L HUSON & ASSOCIATES

REVIEW

Lal Lal Wind Farm
Planning Permit Amendment
August 2016

Job No LHA403
October 2016

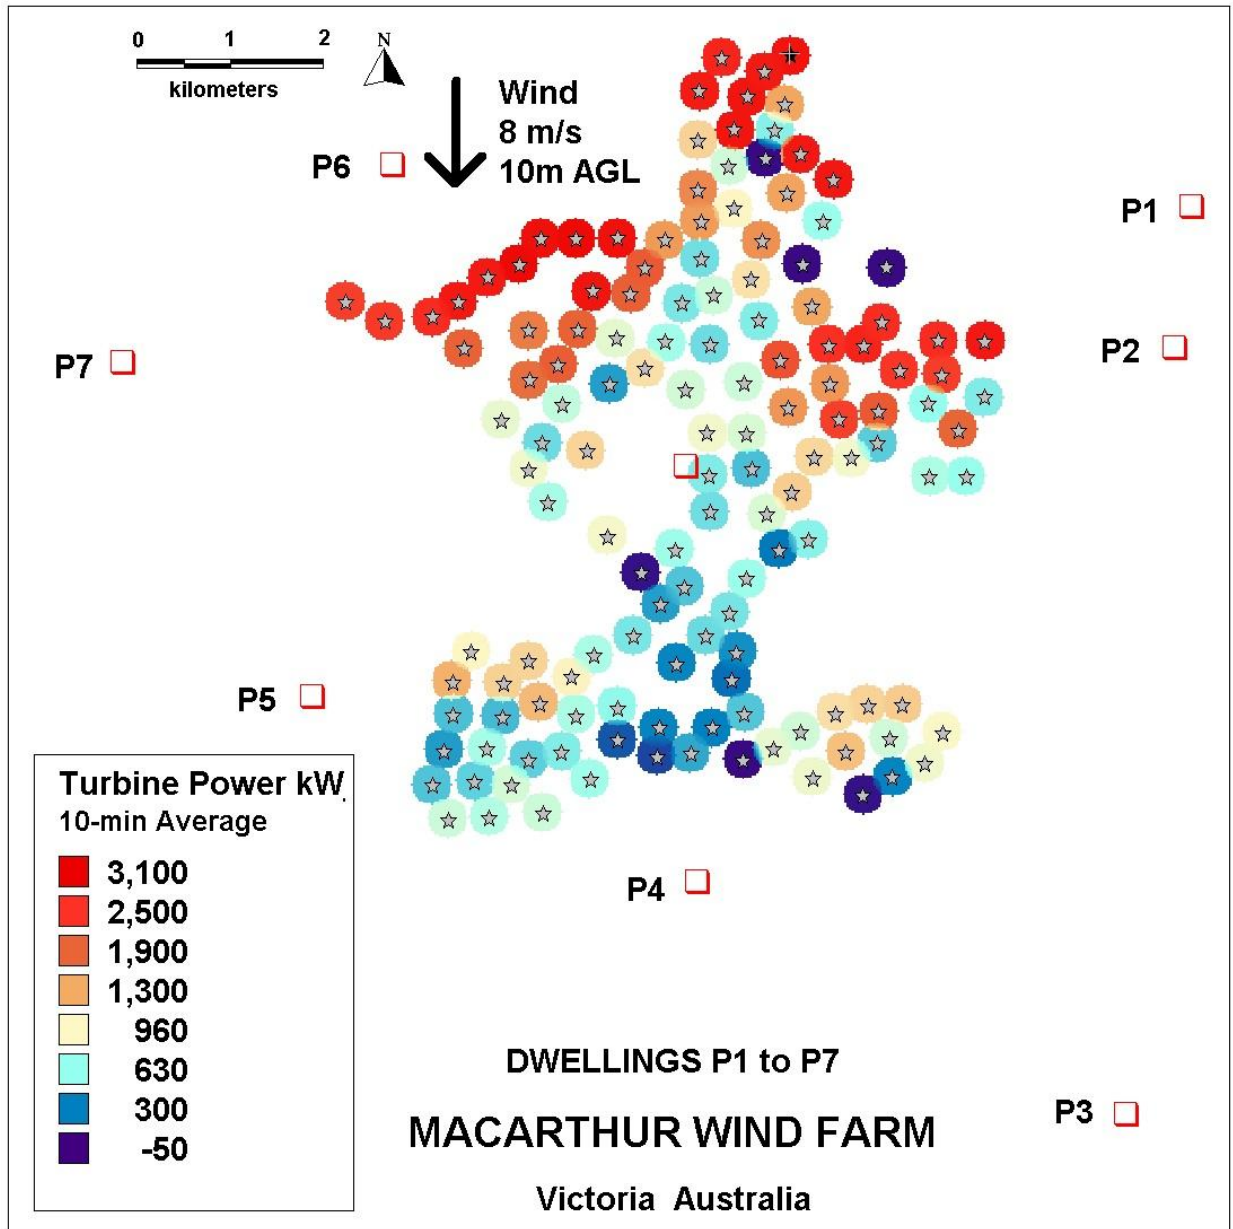
The following figure is from a single 10-minute sample of power output at the Macarthur Wind Farm to show how power output varies across the wind turbine array, as it would for the two Lal Lal sections. Sound output increases with increasing wind speed across any individual wind turbine. This figure shows the shielding effect caused by wake turbulence.

In this situation a wind approaching the wind farm from the north at 8 m/s would be applied in the scatter chart for noise at P4. However, the noise received at P4 is dominated by sound from the wind turbines closest to that location, not those experiencing the 8 m/s wind on the northern edge over 6 km away. The single point entered on the scatter chart will be placed erroneously on the chart such that it would appear that high wind speeds produce lower sound levels at the P4 dwelling. With many such points it would appear that lower sound levels are produced by the wind farm from the compliance scatter chart.

This type of assessment should not be allowed and a method in the Noise Compliance Testing Plan should describe an alternative measurement arrangement where an estimate of the wind speed across the wind turbines closest to the dwellings is required for input on any wind speed / noise scatter chart for compliance testing.

Figure 5 – Tonal audibility of all data points vs wind speed from a sample data set, as per Edition 3.0

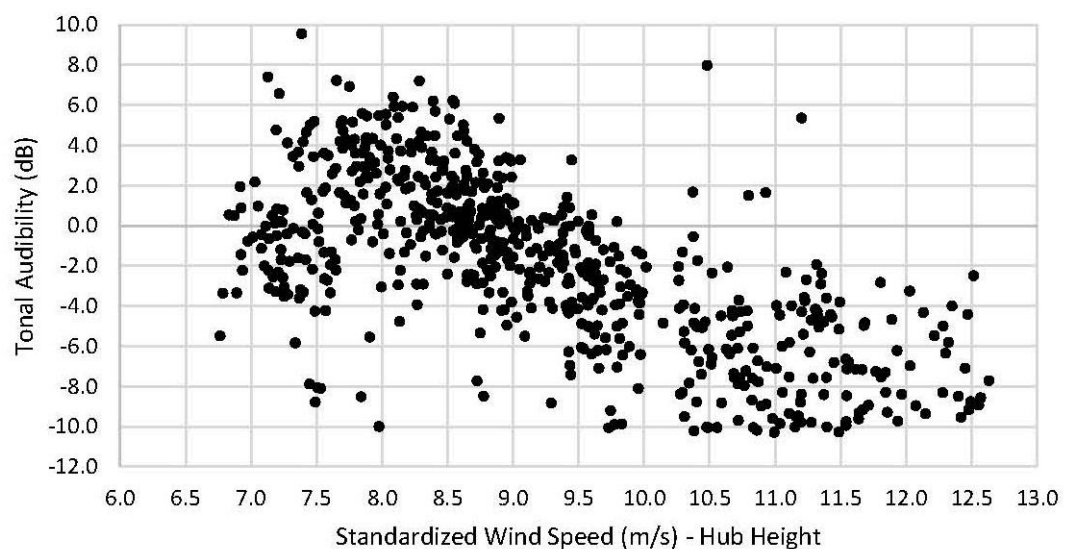
The difference in minimum sample size between Edition 2.1 and Edition 3.0 is small, 12 vs 10 respectively. Edition 3.0, however, utilizes more representative wind speed data (as noted in Section 2.4) which ultimately provides a more accurate indication of the tonal audibility at a given wind speed.

A guarantee of compliance to earlier versions of IEC 61400-11, or the latest version with small sample size, is of little value if the assessment of tonality is “more akin to playing the lottery”. We have no confidence that such a guarantee proposed in the MDA report will achieve the objective of ensuring the absence of tonal special audible characteristics in practice. Furthermore, IEC 61400-11 effectively averages the tonal audibility test results and even if the test result shows no tonal audibility it does not provide a guarantee that tonality will not occur when, from Jozwiak referenced above; “the variation for a given wind speed easily exceeds 5 dB between the min and max values.”
